Re: New York Methodist Hospital
Center for Community Health
505-525 6th Street (Block 1084,
Lots 25, 26, 28, 39-44, 46, 48,
50-59, 164, 1001, and 1002)
BSA Cal. No. 289-13-BZ

We are submitting this letter in connection with the application by New York Methodist Hospital ("NYM" or the "Hospital") for a variance to facilitate the development of a new ambulatory care facility (the "Center") Hospital's main campus in Brooklyn. This letter and the attached materials provide responses to questions asked by the Board at the February 11, 2014, public hearing on the application, as set forth below.

Garage Overbuild Study
ILLUSTRATIVE. FOR INFORMATION ONLY

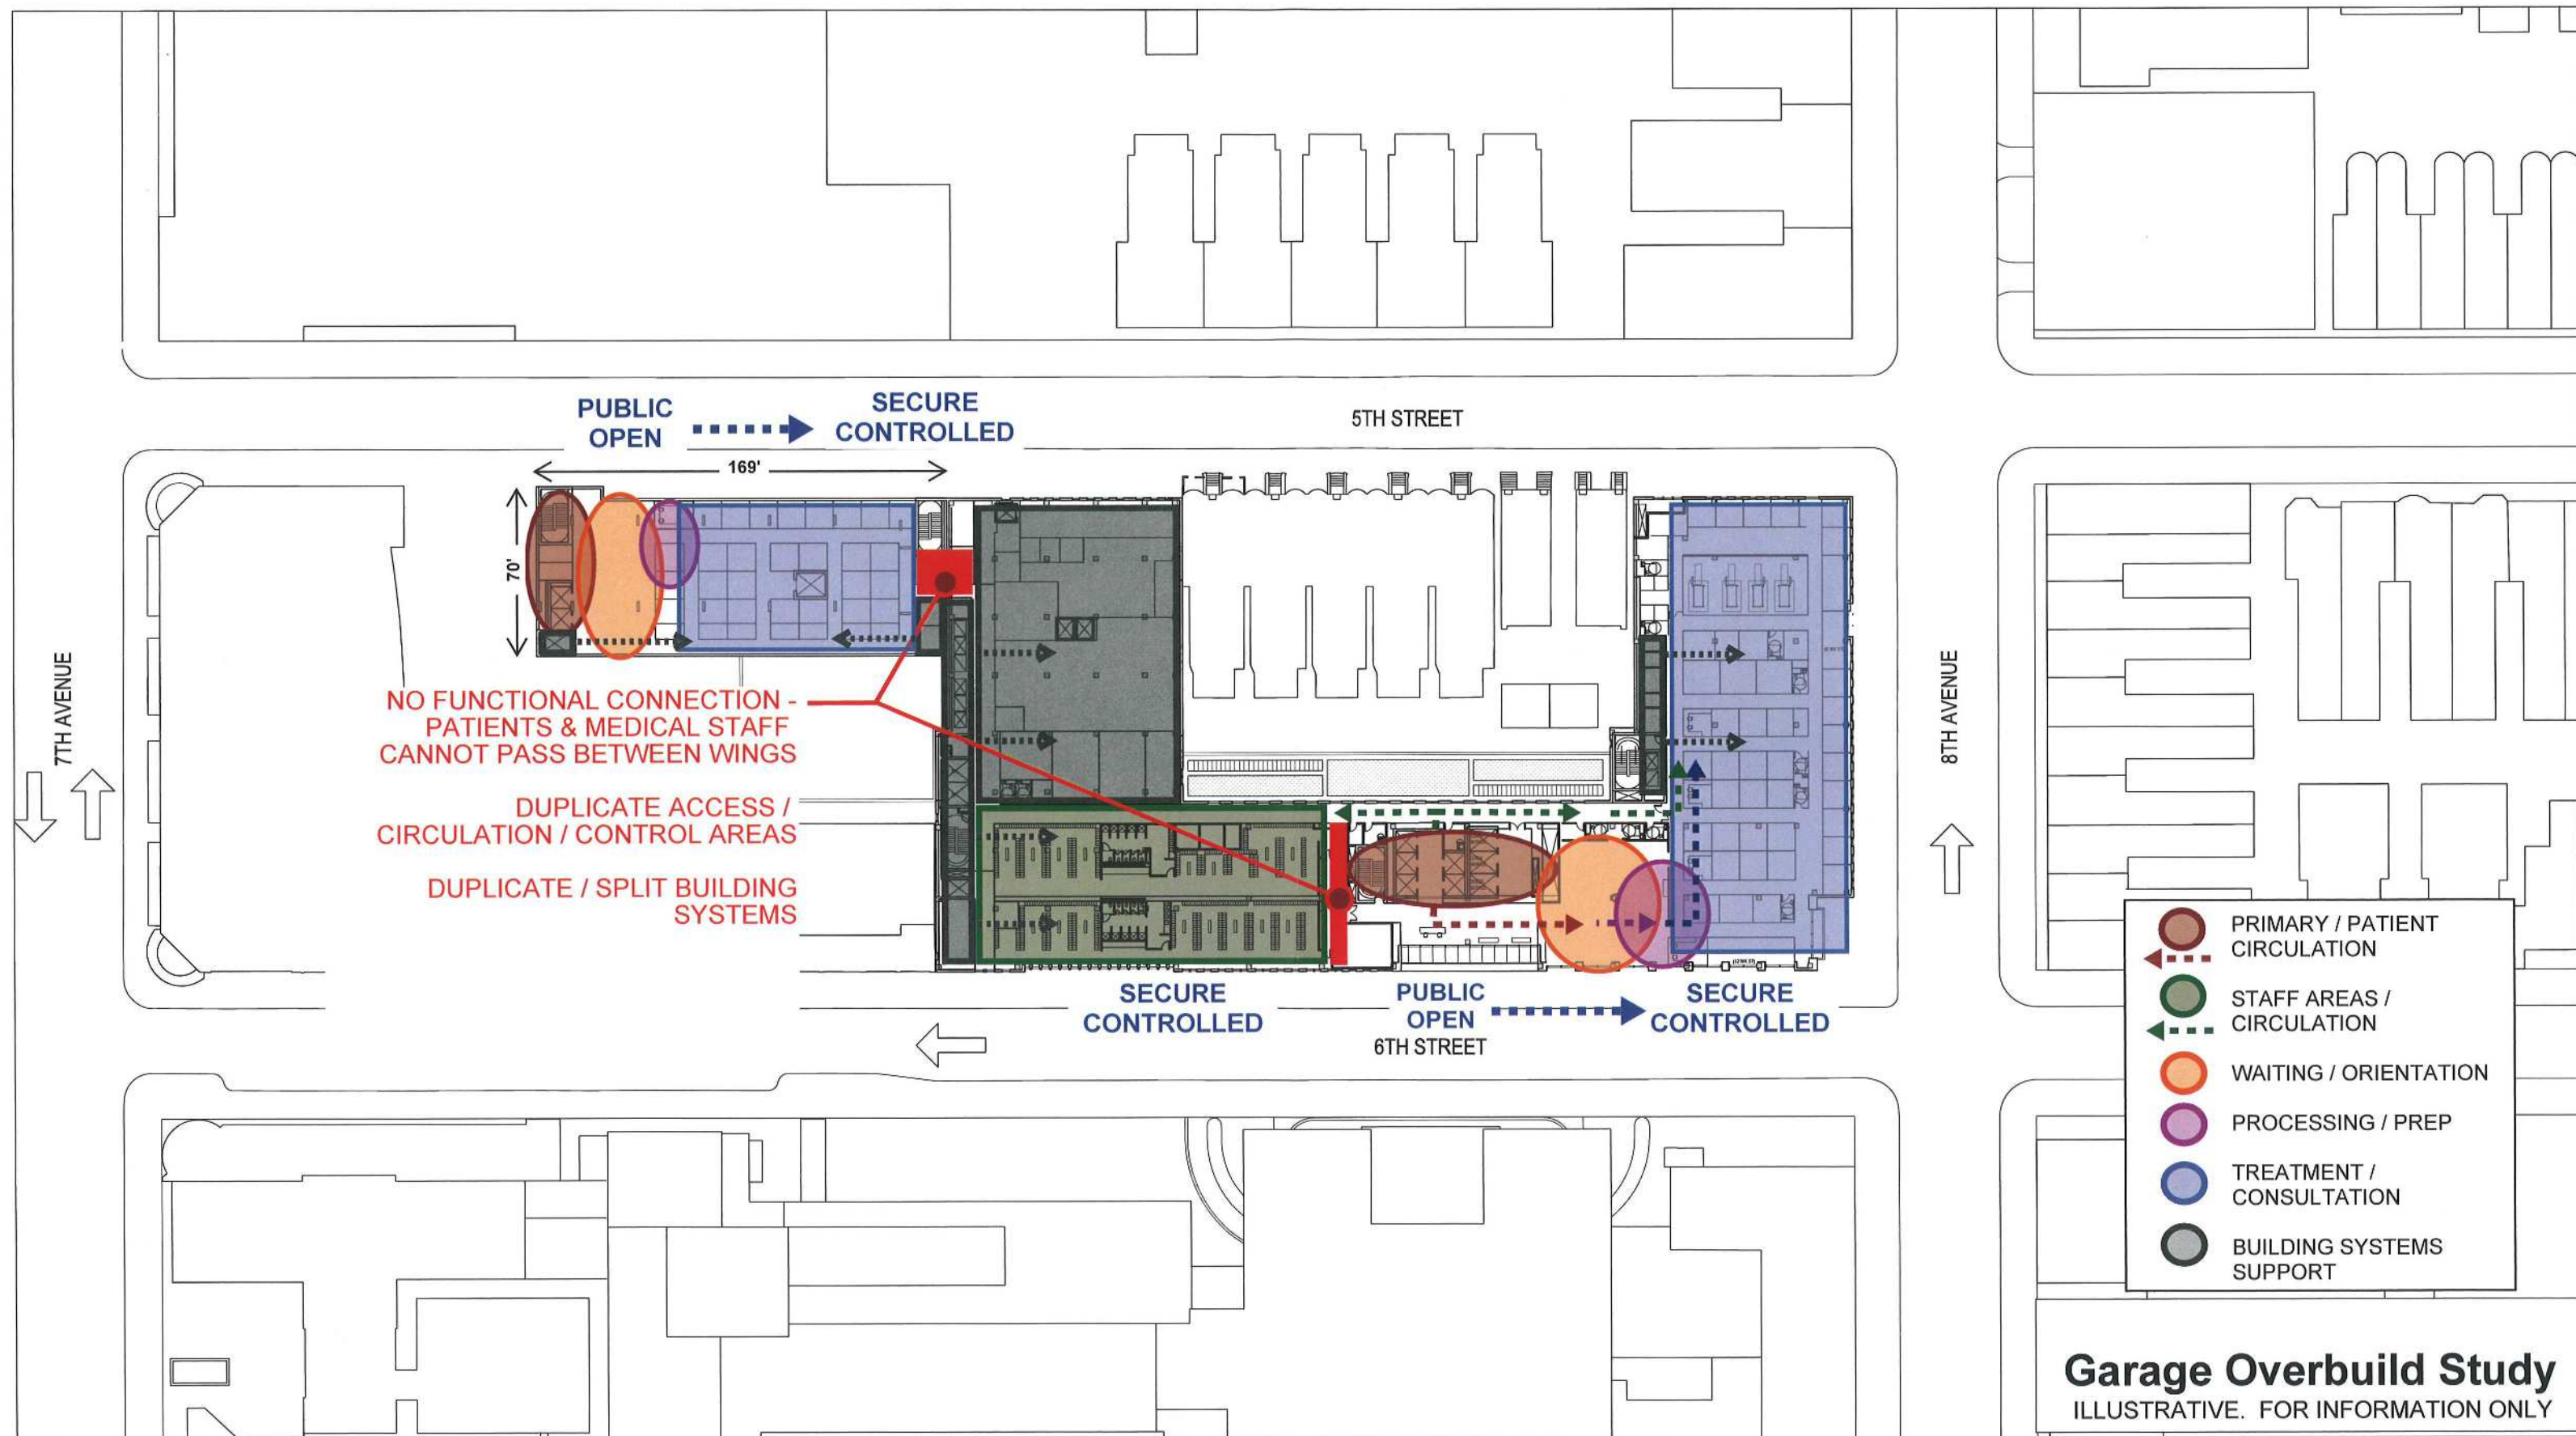
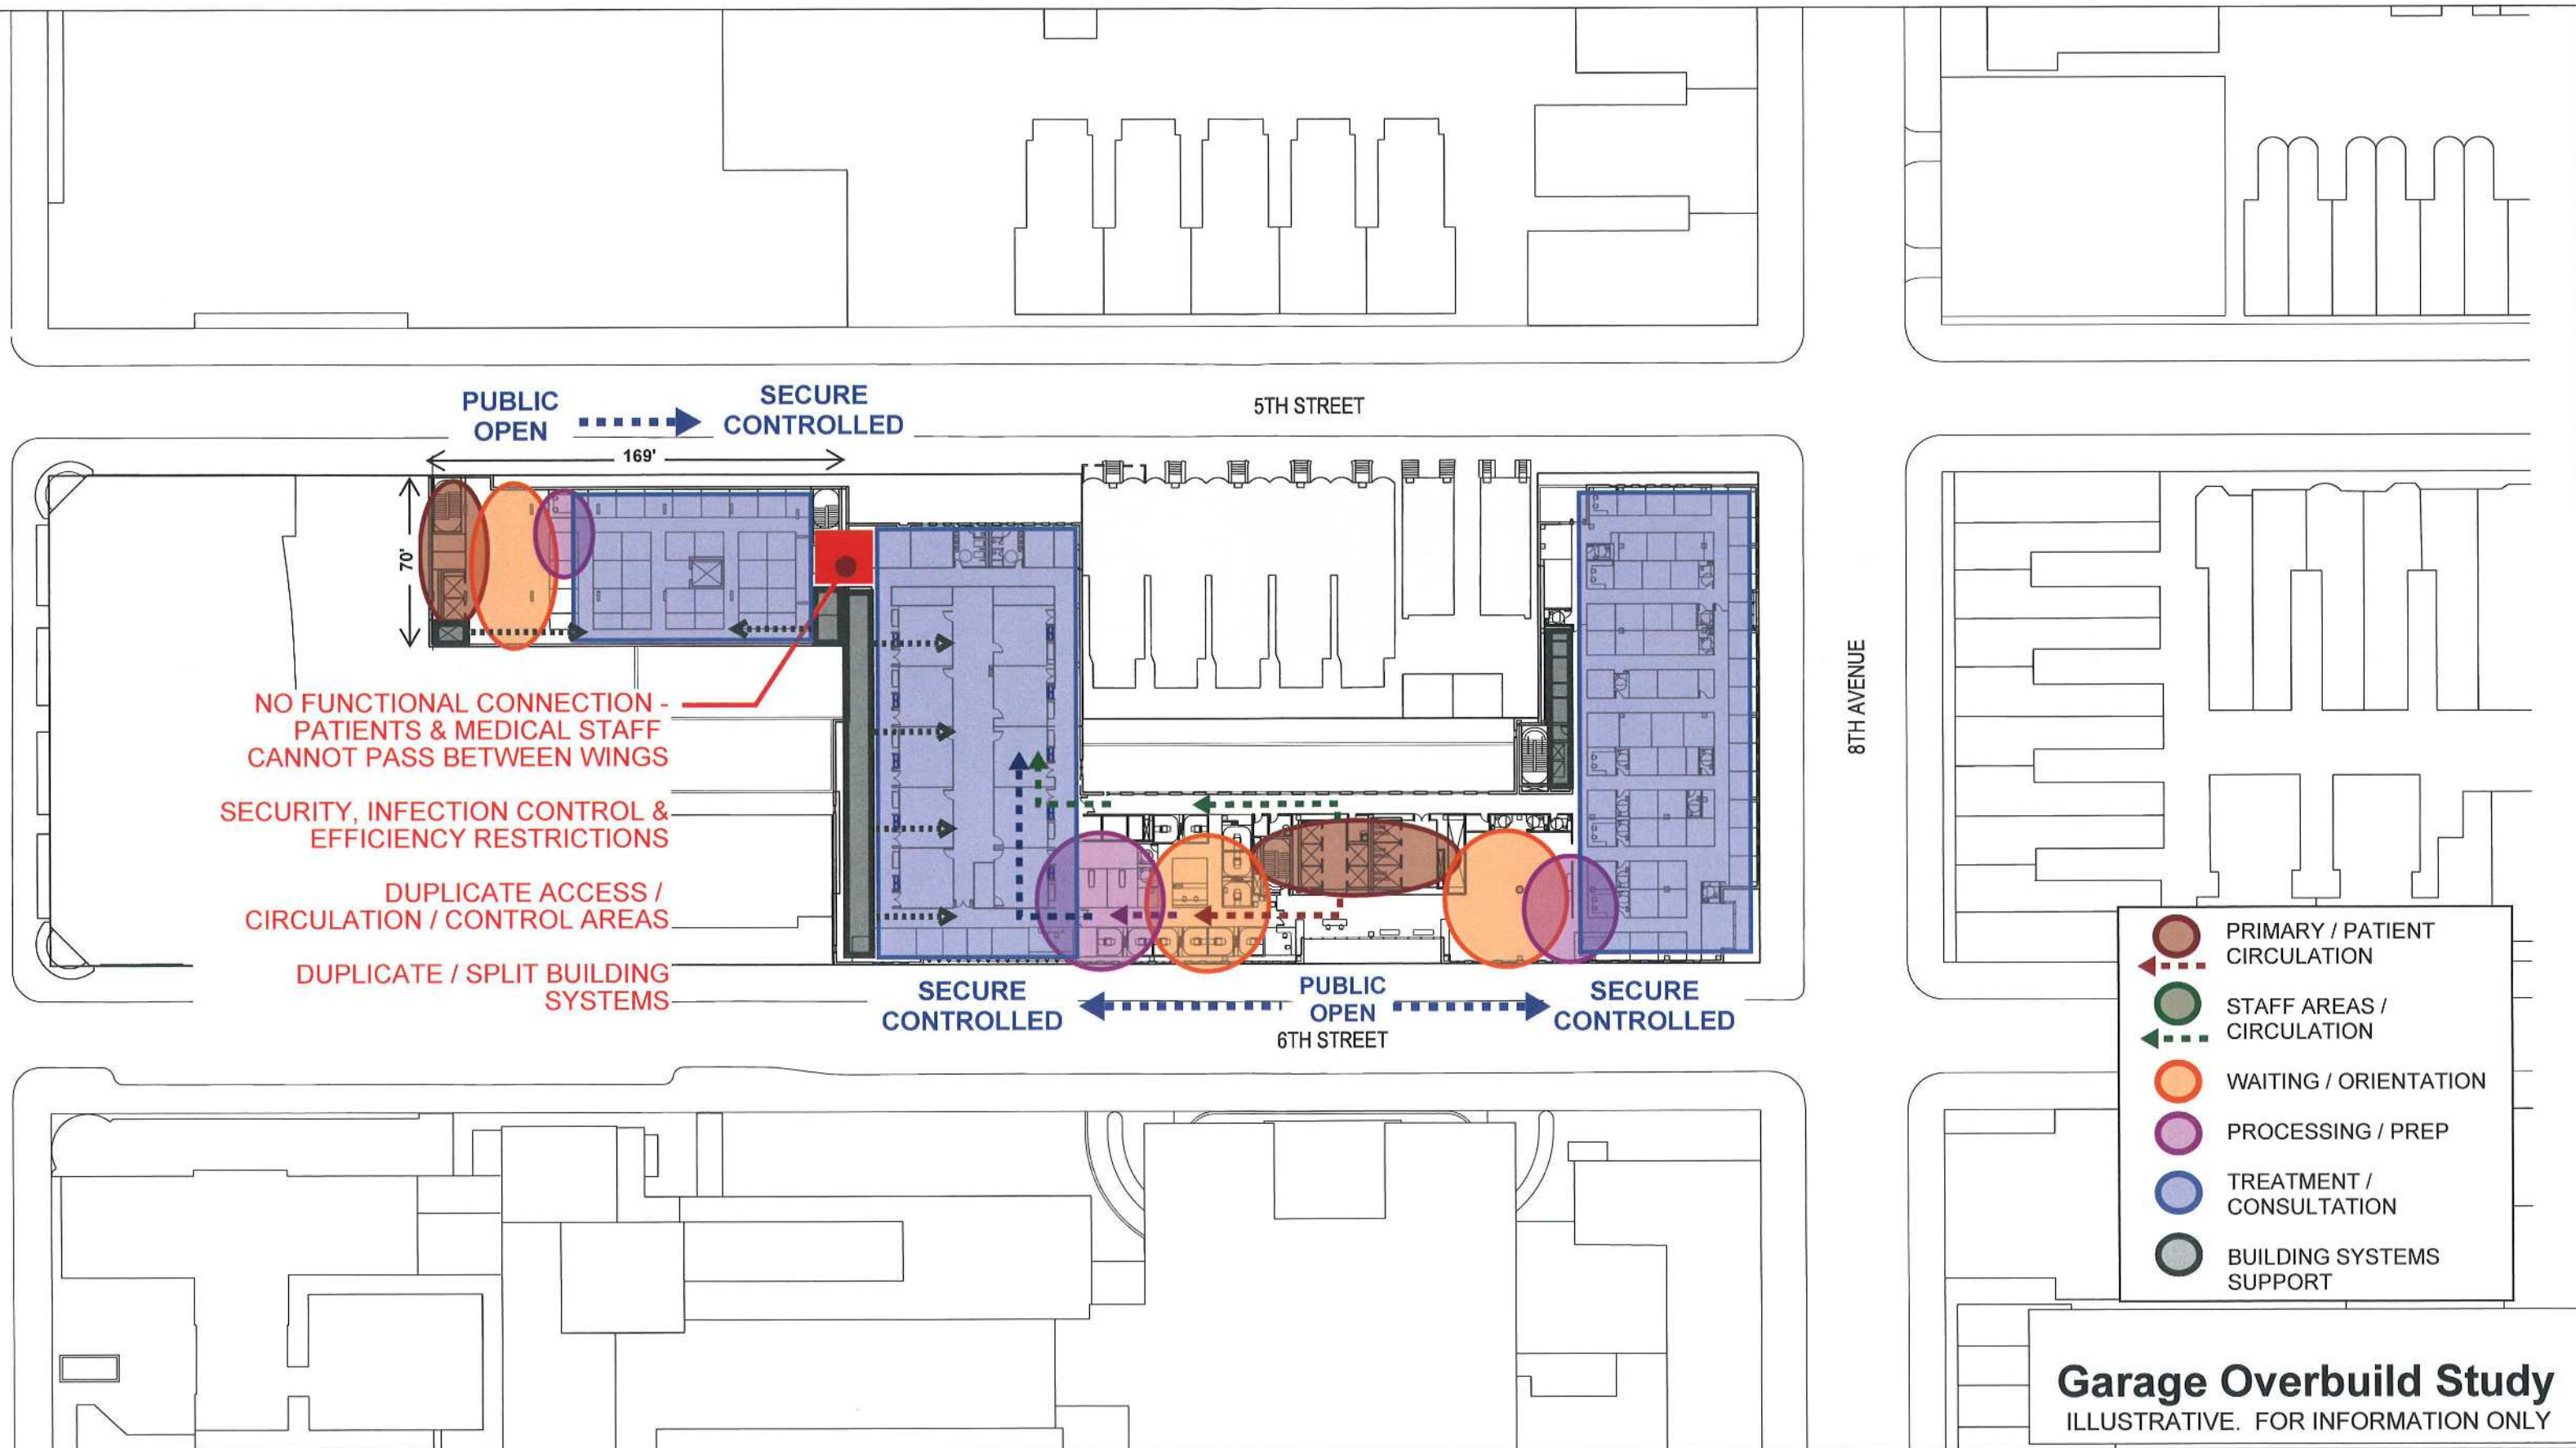
2. *Provide diagrams illustrating the programmatic issues associated with construction a larger portion of the Center, e.g. up to five stories, over the existing Hospital garage.*

An additional wing located over the existing Hospital garage, with a height of five stories (or more or less), would not satisfy the Center's programmatic needs because the geometry would necessitate that it be functionally and operationally segregated from the remaining portion of the building. Connections could not be made between the garage wing and the main building because (i) the vehicular driveway and loading area would separate the garage wing and the rest of the building on the ground floor (see Ground Floor Plan Diagram) and (ii) security, infection-control, and operational standards for the ambulatory surgery facilities would prohibit pass-through access to the garage wing on the 2nd through 4th floors, which house CSS, PACU, and the ORs (see 2nd Floor Plan through 4th Floor Plan Diagrams). A connection would be possible only at the 5th floor, and even then would create a very long, inefficient circulation network between the main portion of the new facility and the garage wing of the building—a circulation network which would run through departments rather than distribute to them efficiently from a central core. In addition, the program areas within the garage wing and western wing on the 5th floor would have no functional relationship to each other, and therefore any connection between them would be detrimental to such programs and introduce security, infection, and efficiency concerns. (See 5th Floor Plan Diagram)

Such a design would also require an additional vehicular drop-off and pedestrian entrance on 5th Street, since almost all of the garage wing's floors, including the ground floor, could not be accessed from the building's central circulation core on 6th Street. This configuration would require an inefficient utilization of space, with more area dedicated to vertical and horizontal circulation and vehicular access, and would result in increased vehicular traffic on 5th Street. (See Ground Floor Plan Diagram) In short, the building would have the same deficiencies as the Complying Development. To the extent that the garage wing complied with applicable height and setback and rear yard equivalent regulations, it would similarly contain very narrow floor plates, capable of accommodating only inefficiently small suites for the Hospital's clinical institutes.

The attached Garage Overbuild Study demonstrates the programmatic deficiencies of a development that includes construction over the existing Hospital garage. The proposed design configuration of the Center on the U-shaped development site is based on a design principle by which two distinct circulation paths are provided (i) for patients and (ii) for staff, oriented around a centrally located core, with patients led progressively toward more controlled, private, and dedicated spaces—from the waiting area to registration, then to processing, then to preparation, and finally to treatment in the eastern and western wings of the building. This design not only provides a rational, efficient circulation network, but it is also needed to accommodate certain ambulatory care facilities in the building. The surgical suite, for example, must be located in the Center's western wing because the central core area and eastern wing do not have sufficient dimensions to accommodate the facilities. The PACU unit and CSS, which must be adjacent to the surgical suite, are therefore also located in the western wing, on the floors immediately above and below.
